DWR FIELD OFFICE APPLICATION FOR APPROVAL TO CHANGE THE PLACE OF USE AND/OR THE POINT OF DIVERSION

Water Right - #3236 CHANGE IN PLACE OF USE APPLICATION MAP

Re: Water Right, File No(s). 3236

Re: Place of Use Change Application, File Nos. 3236 & 8429

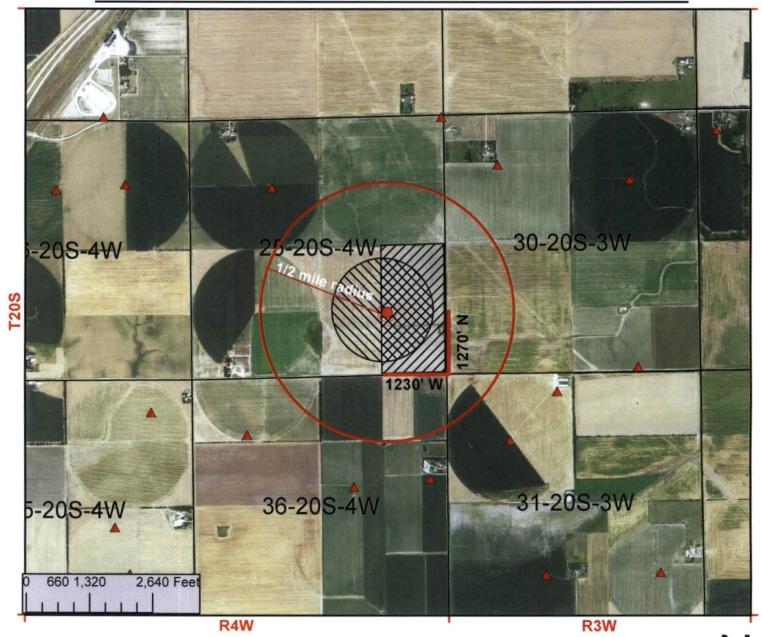
The change applications propose to reconfigure the 80 acre place of use to an 80 acre circle. An identical place of use overlap between the water rights currently exists and is also proposed by the change applications. The proposed place of use results in a water to land ratio of approximately 1.37 acre-feet per acre.

Complies with K.A.R. 5-22-8. Proposed 80 acres is a 7 acre (9.6%) increase of the 73 base acres. Authorized PD location is also being corrected to 1248' N & 1305' W based on GPS. Recommend Approval, Complies with K.A.R. 5-22-1 through 5-22-1 through 5-22-17

The District's review found that the change applications comply with the Revised Aquifer Management program approved by the Chief Engineer and with the District's Rules and Regulations K.A.R. 5-22-1 through 5-22-17. Based upon the review, the applications are recommended for approval by the Equus Beds Groundwater Management District No. 2.
